**East West Rail Transport and Works Act Order (TWAO) Application
Response from Buckinghamshire County Council**

Ref: East West Rail Transport and Works Act Order Application - Response from Buckinghamshire County Council

Back Brook (458043, 226176):

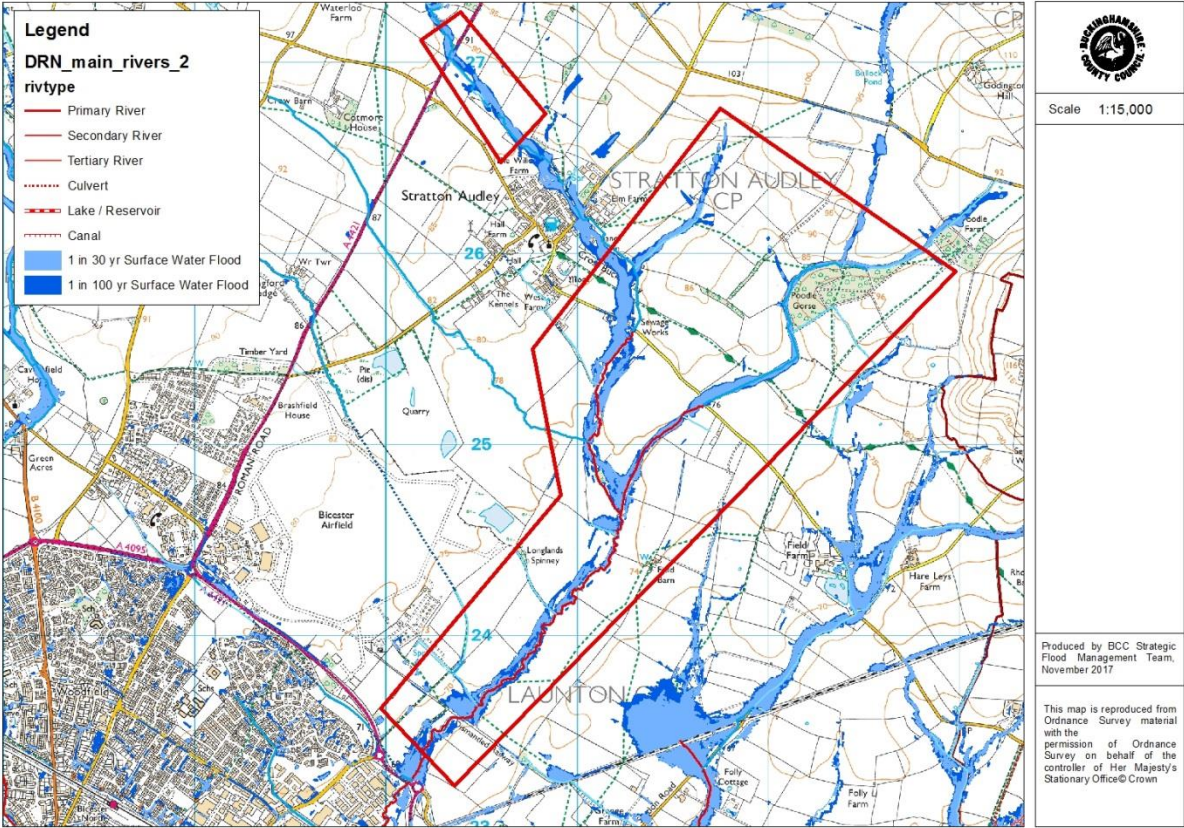
Woodland planting and other Natural Flood Management Techniques could be used in the upper reaches of the Back Brook (where it is classified as ordinary watercourse but has flood zones). There is a good opportunity to plant trees to connect woodland areas south of Bainton.

Bicester Airfield (459940, 224620):

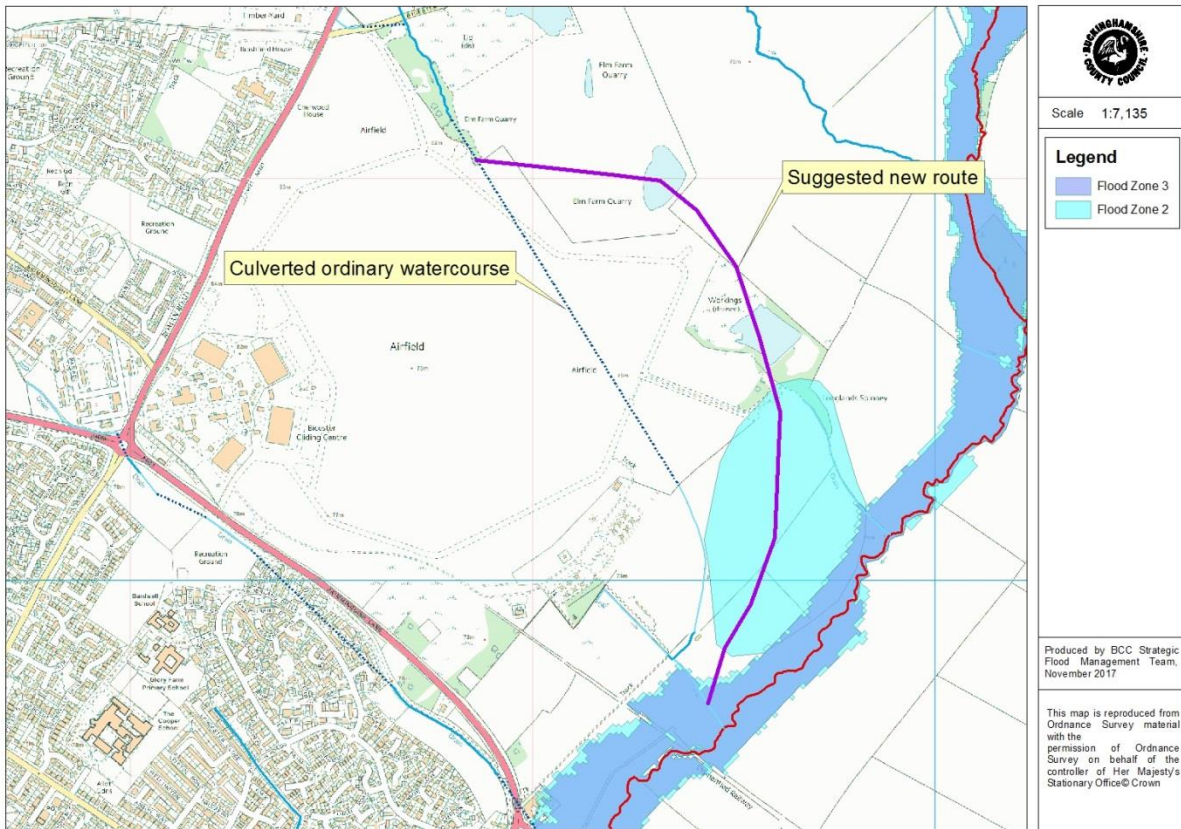
One of the tributaries of the Audley Brook is culverted through Bicester Airfield. There is an opportunity here to de-culvert the watercourse, or leave the culvert in place and divert the watercourse round to the east of the airfield, connecting it up with the series of offline ponds and reconnecting it to the patch of Flood Zone 2.

Launton Brook (461541, 223440):

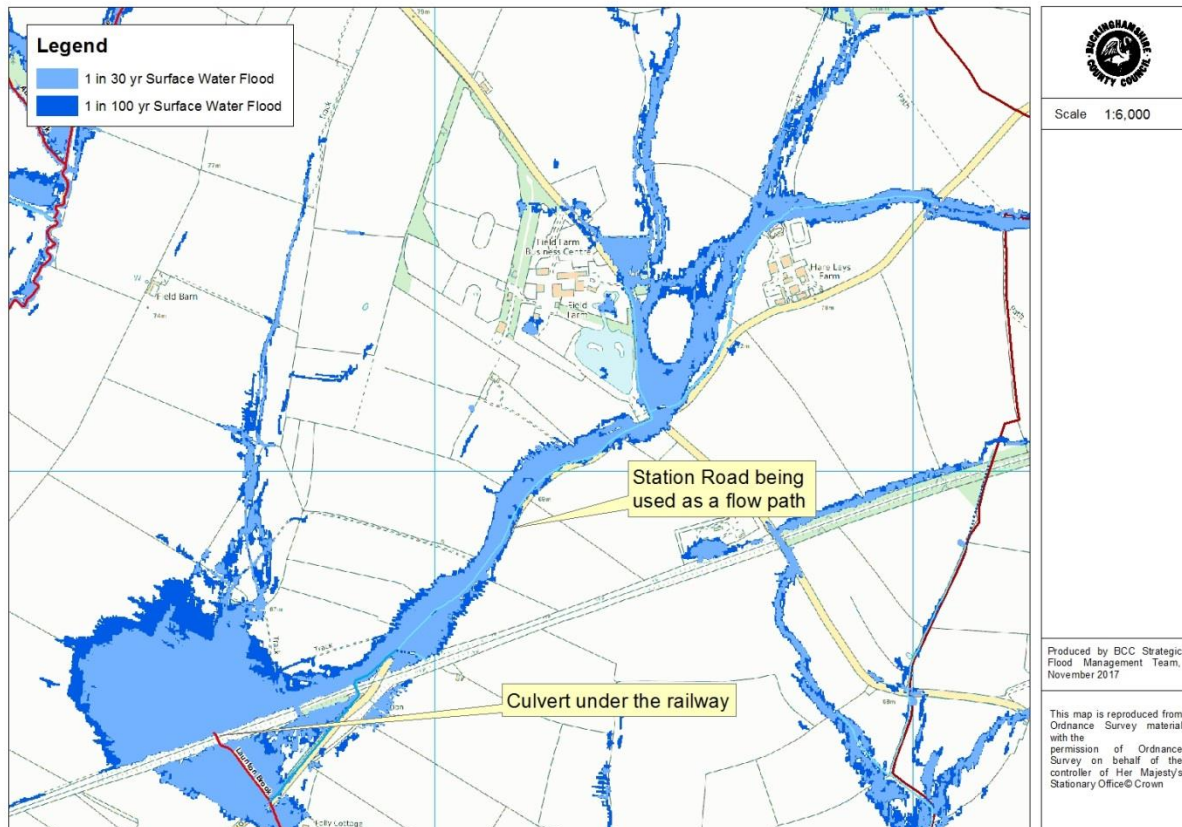
Where the Launton Brook becomes main river (culvert under the current railway line), the culvert should remain the same size or be reduced in size. This culvert should not be made bigger to ensure surface water flow volumes do not increase downstream. There is a large surface water flow along Station Road, some upstream storage could be put in place to slow and reduce the volumes flowing downstream, some measures could be taken on Station Road to divert the flows off the road and onto neighbouring fields.

Claydon Brook (474561, 227578):

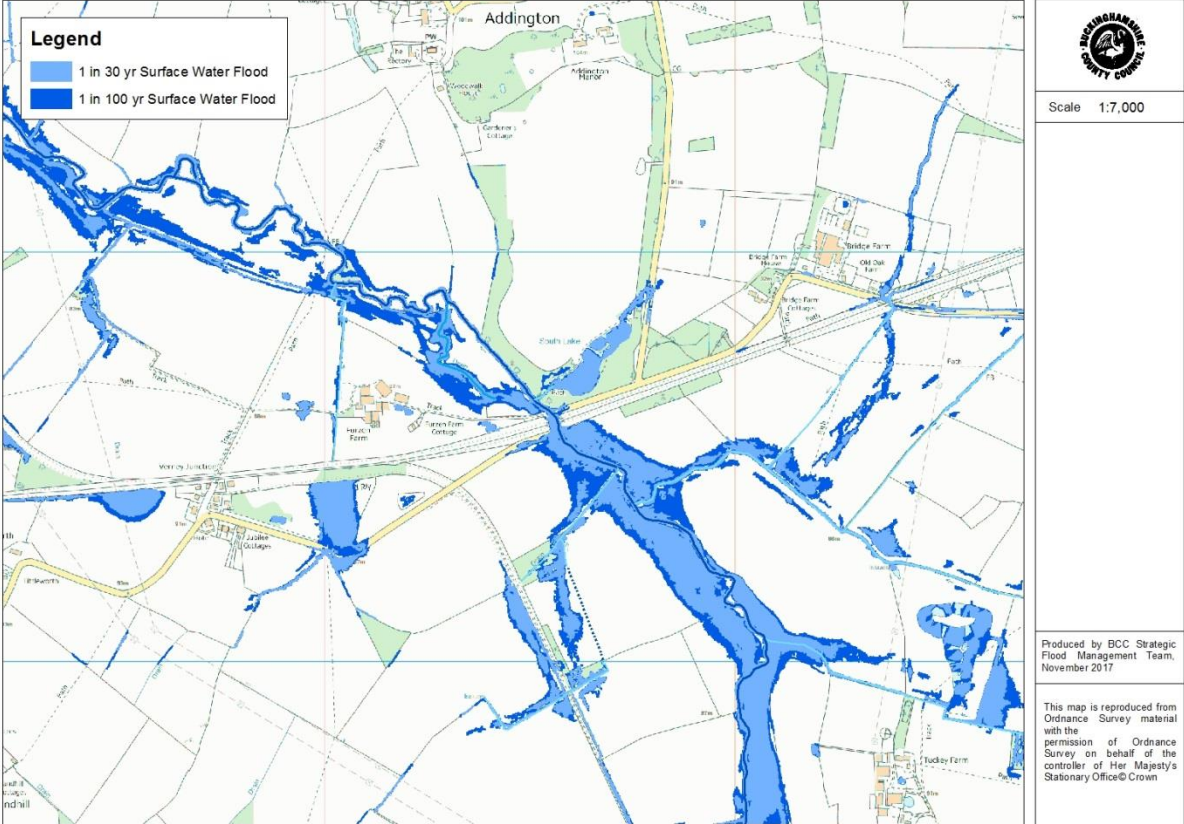
Where the Verney Road crosses the railway and the Claydon Brook, there are records of flooding on the road. Natural Flood Management techniques to store and slow flows upstream of this crossing could reduce the flood impact here.

Winslow Road (477801, 228709):

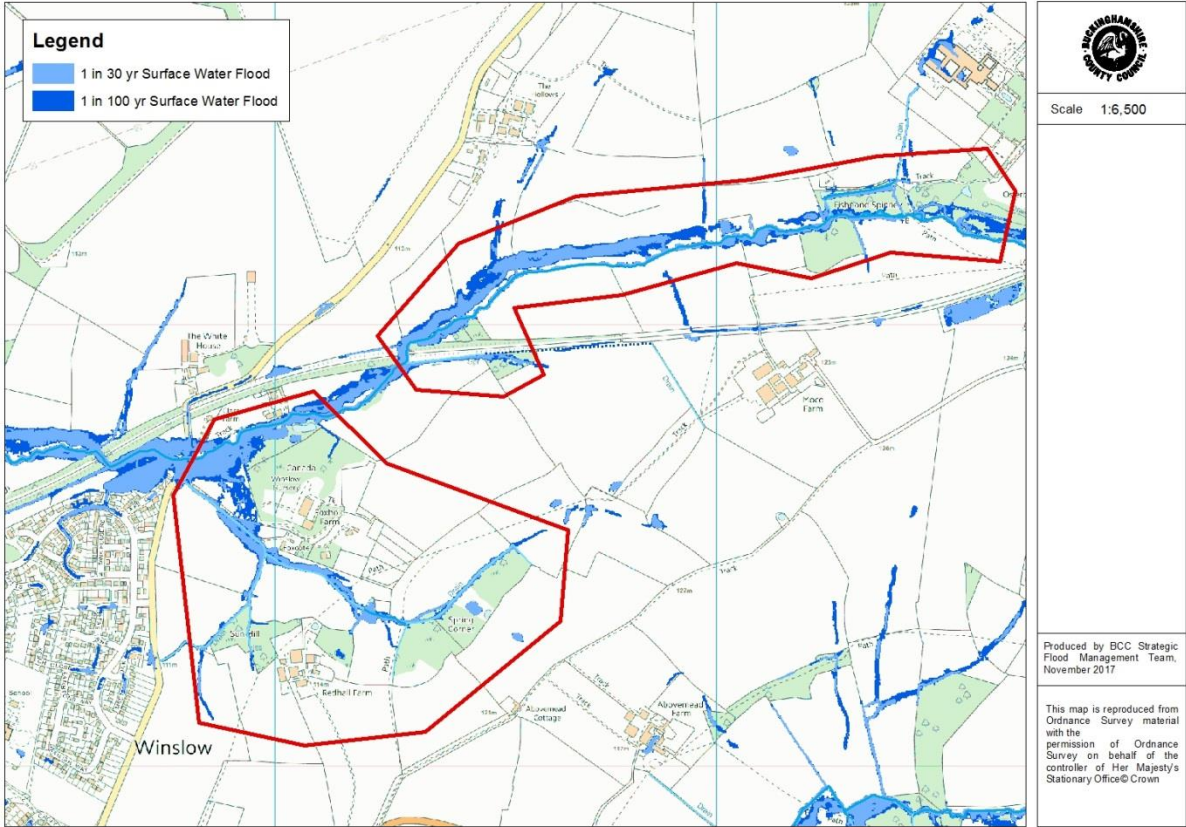
We have records of surface water flooding on Winslow Road where it goes under the railway and where the tributary of Claydon Brook flows under the road. In order to reduce the risk here there could be some upstream storage or/and woodland planting to reduce and slow the flows in this location. The areas identified for the Natural Flood Management techniques are outlines in red on the figure above.

Location 3: South of A41 Waddesdon Manor

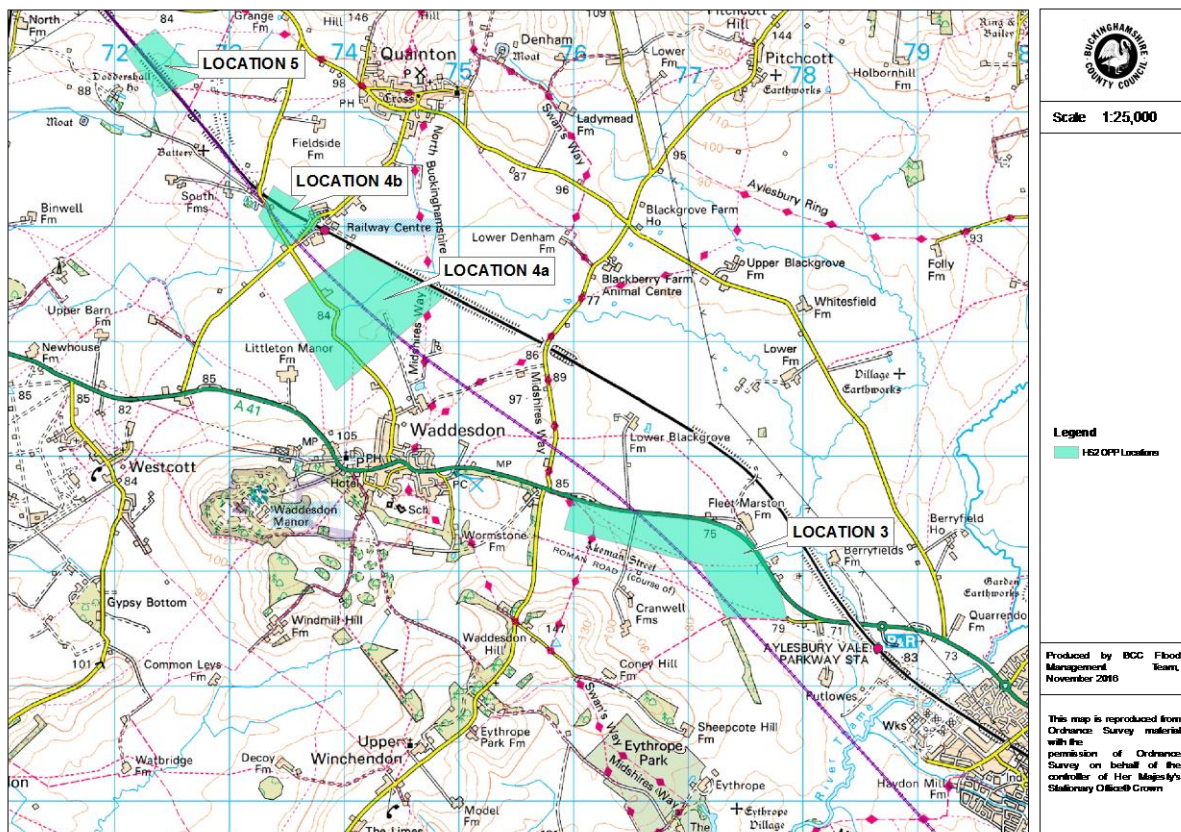
There is a large surface water flow route here. Opportunity for some storage/wetland creation here to reduce the flows onto the A41, as this road is known to flood regularly. In the same location something could be done to improve the drainage on Waddesdon Hill, as this road is also regularly wet and there has been a recent car accident.

Location 6: Calvert to Quainton

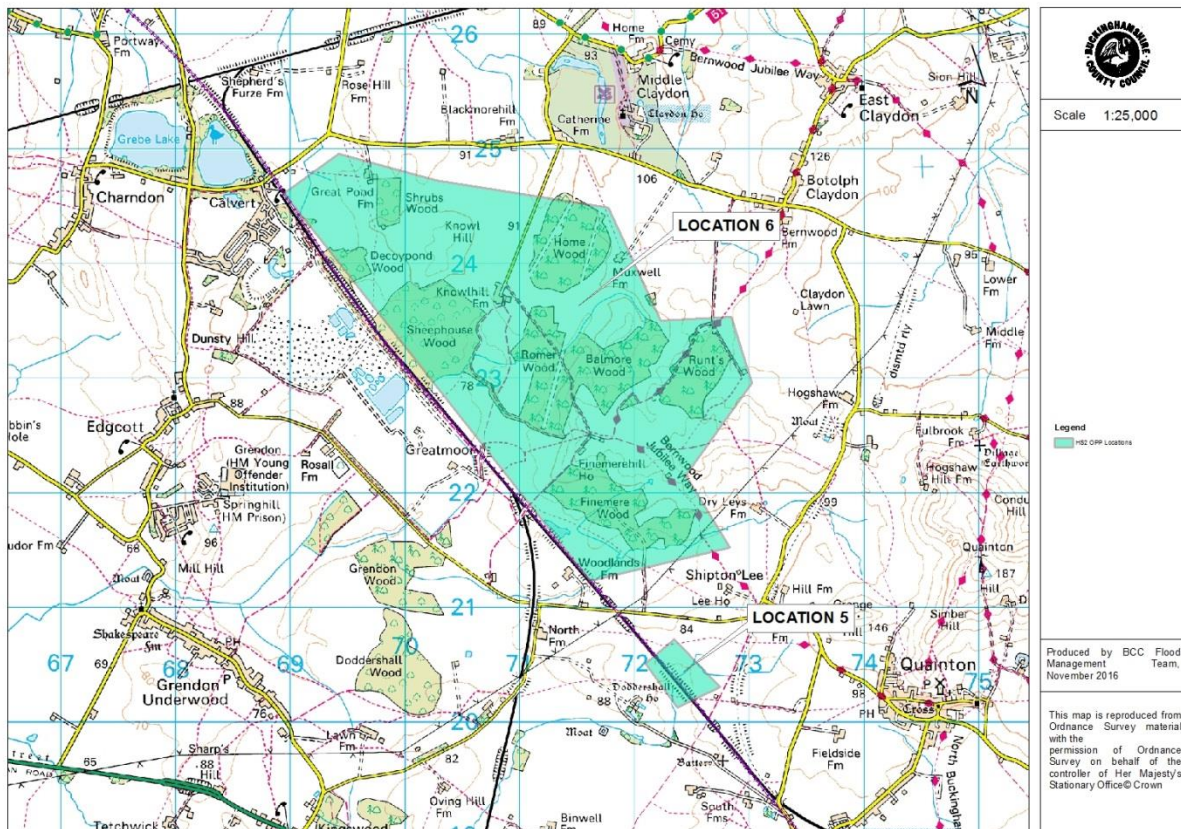
Woodland planting to create corridors and connectivity between woodland patches; Shrubs Wood, Decoypond Wood, Home Wood, Sheephouse Wood, Romer Wood, Balmore Wood, Runts Wood and Finemere Wood. The increased planting would also have a positive effect on surface water.

Location 14: Calvert Jubilee

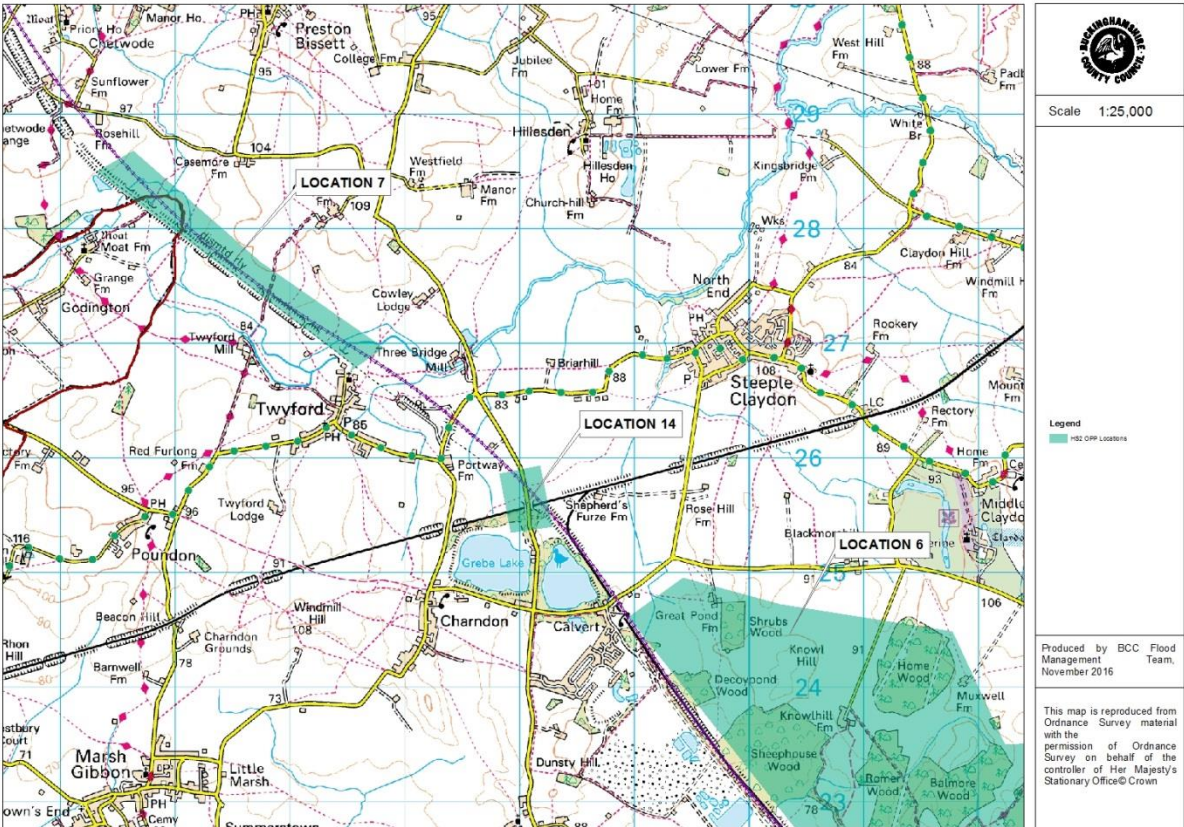
Known flooding on Perry Hill Road north of Calvert Lakes. Sustainable drainage could be used to improve this problem.
